**MARKED-UP PROPOSED TECHNICAL SPECIFICATIONS PAGES FOR
CURRENT TECHNICAL SPECIFICATIONS
CATAWBA NUCLEAR STATION**

**PROPOSED TECHNICAL SPECIFICATIONS PAGES FOR PLANNED
DIVIDED TECHNICAL SPECIFICATIONS
CATAWBA NUCLEAR STATION**

BACKGROUND AND DESCRIPTION OF REQUEST

PLANNED MODIFICATION TO PROCESS PENETRATION M308

ELEVATION VIEW- SEALED PENETRATION (M-308)

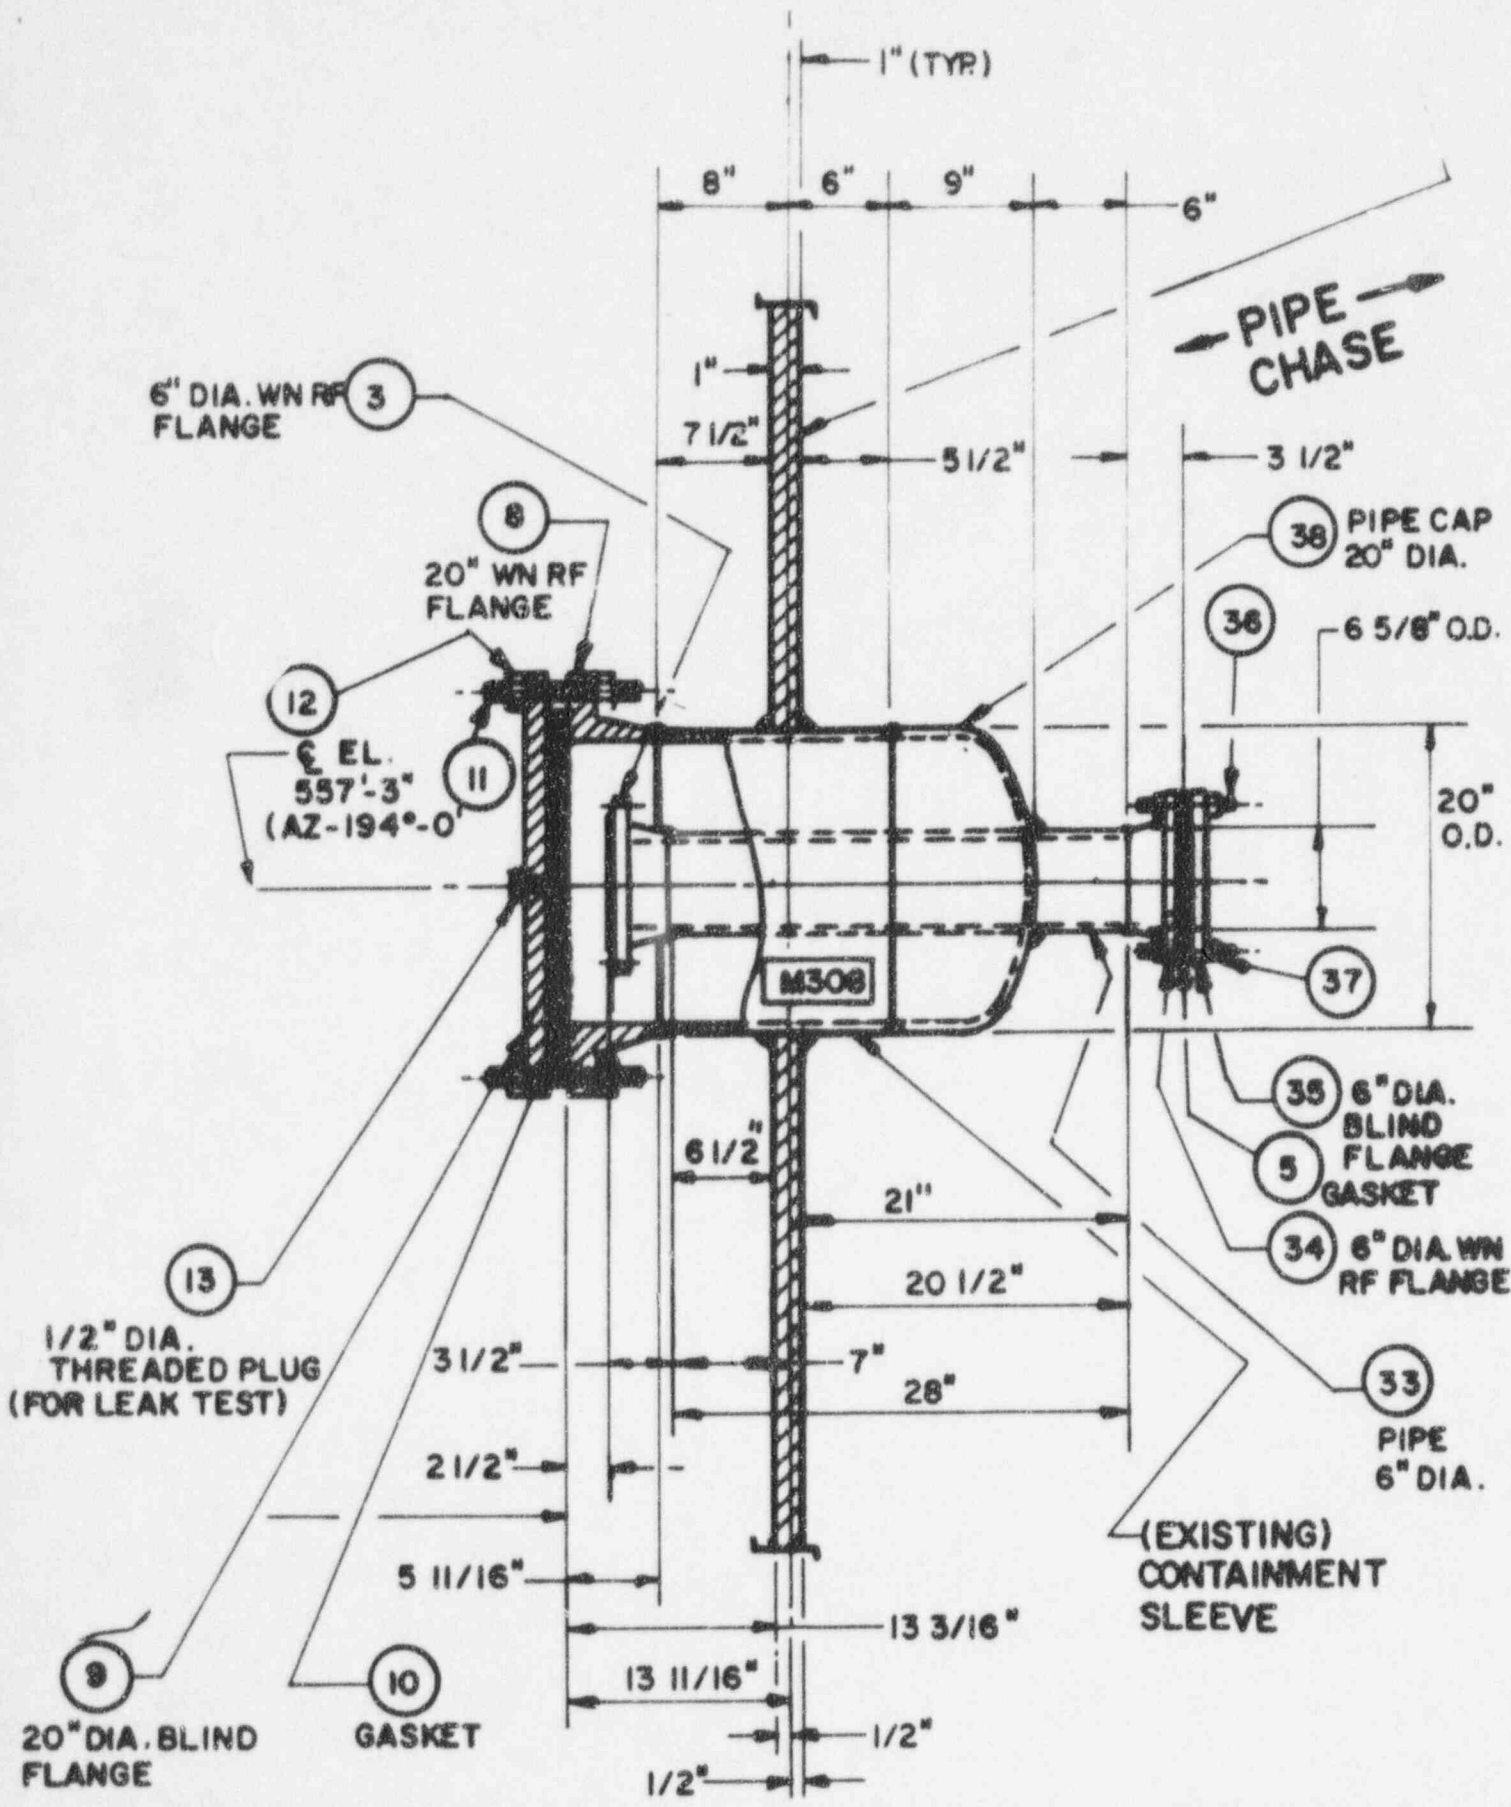
Duke Power Company plans to implement modifications for both units to remove containment isolation valves RN-429A and RN-432B of penetration M308, remove associated wiring and control room instrumentation, cut / cap tubing providing Containment Valve Injection Water to these containment isolation valves during Unit 1 refueling outage 1EOC9 (currently scheduled to begin in June, 1996) and Unit 2 refueling outage 2EOC8 (currently scheduled to begin in March, 1997). This planned modification also deletes all but a small portion of process penetration M308 piping such that the remaining section of piping is capped on each end, both inside and outside of containment, with removable flanges for temporary use during refueling outages to support containment cooling. A test connection will be provided for the required post-modification test, periodic Type B leak-rate tests, and subsequent 'as-needed' retests following use of the penetration. The reliability of containment isolation and integrity will be improved by this planned modification. Please refer to Attachment 5 (Modified Process Penetration M308) for a detailed sketch of the planned modification to penetration M308.

This Technical Specification amendment request addresses the containment integrity function of process penetration M308 relative to secondary containment bypass leakage paths and containment isolation. This proposed Technical Specifications change removes process penetration M308 and containment isolation valves RN-429A and RN-432B from Technical Specifications since planned modifications to modify penetration configuration, which includes removal of associated containment isolation valves, effectively relegates the penetration to a spare penetration with provisions for temporary use only during refueling outages. Appropriate post-modification Type B leak-rate testing, subsequent Type B periodic leak-rate testing and retesting following use, will be performed

Since the sealing of process penetration M308 will be performed per the requirements of the applicable ASME code piping safety class requirements, the confidence in the pressure boundary will be equivalent to the component as originally designed. Therefore, this Technical Specification amendment to remove process penetration M308 from Technical Specification Tables 3.6-1 and to remove containment isolation valves RN-429A and 432B from Technical Specification Table 3.6-2a and Table 3.6-2b will not increase the probability or consequences of an accident that has been previously evaluated.

This proposed change to Technical Specifications will not cause a significant reduction in the margin of safety. Upon completion of the removal of containment isolation valves RN-432B and 429A and the subsequent sealing of process penetration M308, the penetration will be Type B leak rate tested as part of post-modification testing, and will be retested periodically and following each use of the penetration for temporary containment cooling purposes during refueling outages. Therefore, the fuel, cladding, reactor coolant pressure boundary, and containment are not negatively affected by the proposed Technical Specification amendment. No assumptions made in any accident analysis are compromised by this proposed Technical Specification amendment.
